ARM Group LLC

Ms. Barbara Brown
Project Coordinator
Maryland Department of the Environment
1800 Washington Boulevard
Baltimore, MD 21230

Re: Comment Response Letter:
Phase II Investigation Report
Area B: Parcel B14
Tradepoint Atlantic
Sparrows Point, MD 21219

Figure
1

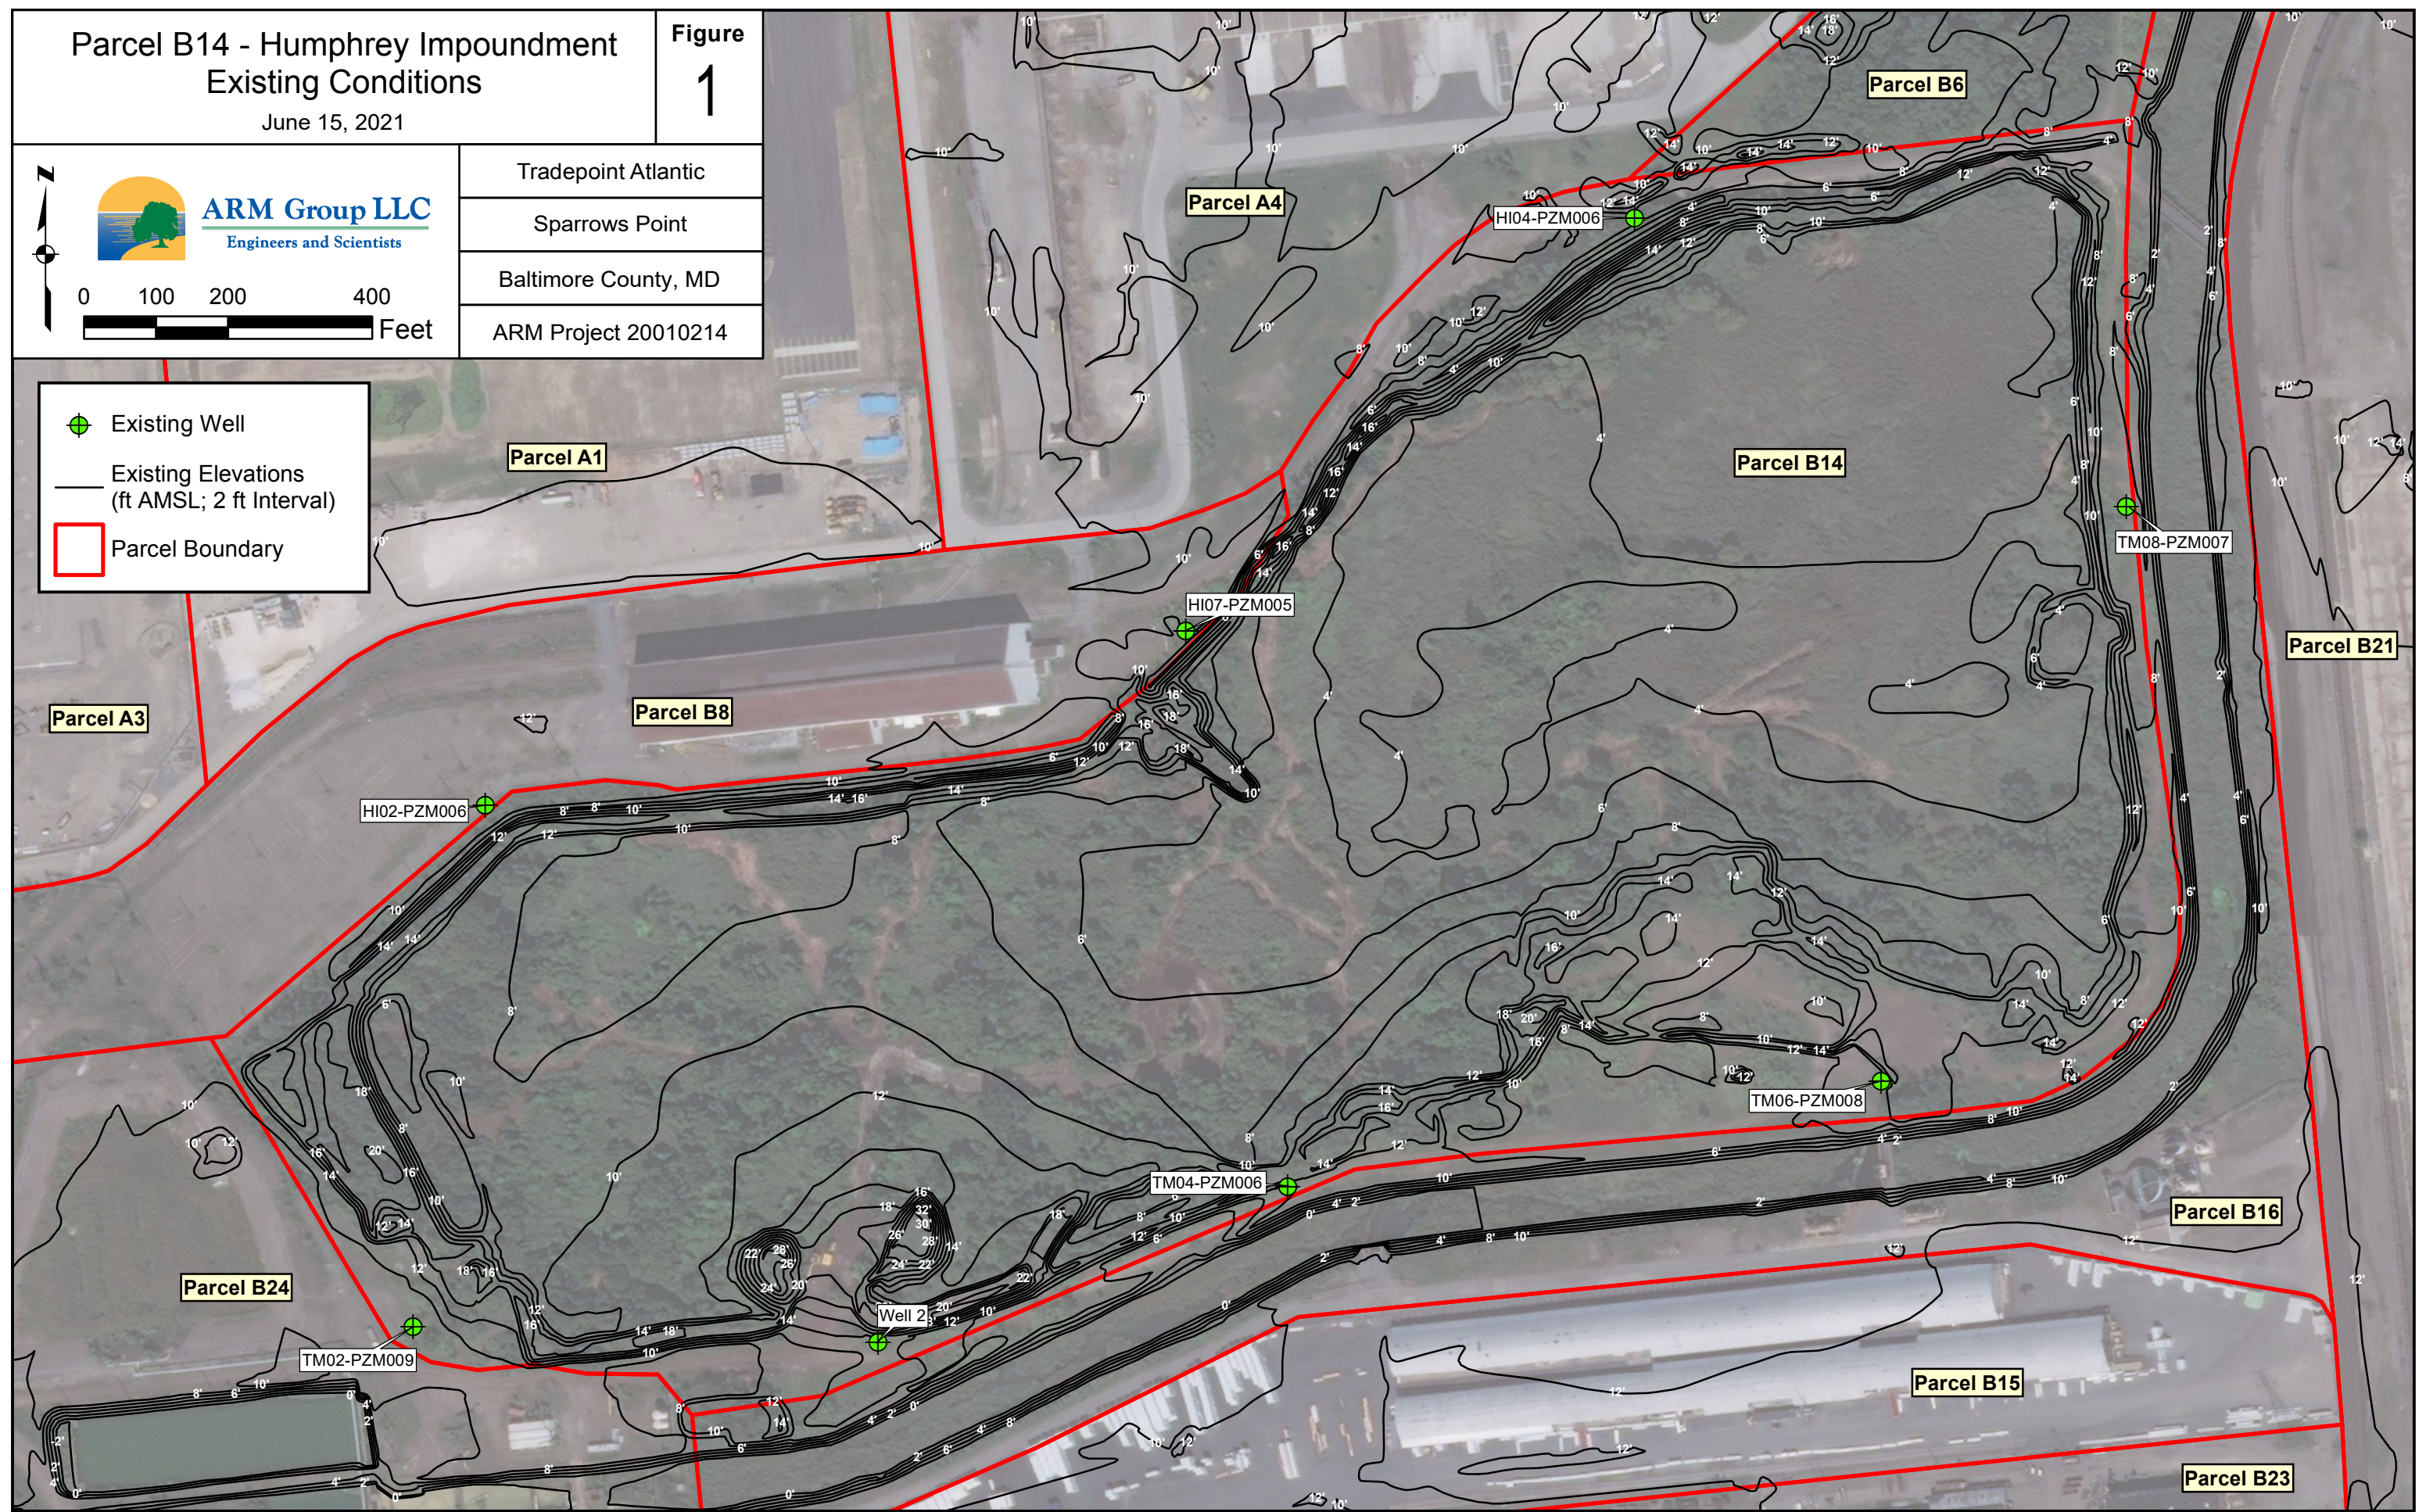
5. *Section 3.3 Groundwater Investigation - Please add language detailing whether permanent groundwater wells sampled as part of this investigation are located on the interior or exterior of the berm located on the property. Or, note if the well is located within the berm material itself.*

Based on elevation data from existing topographic contours, shown on **Figure 1**, the wells are located outside or on top of the berm structure.
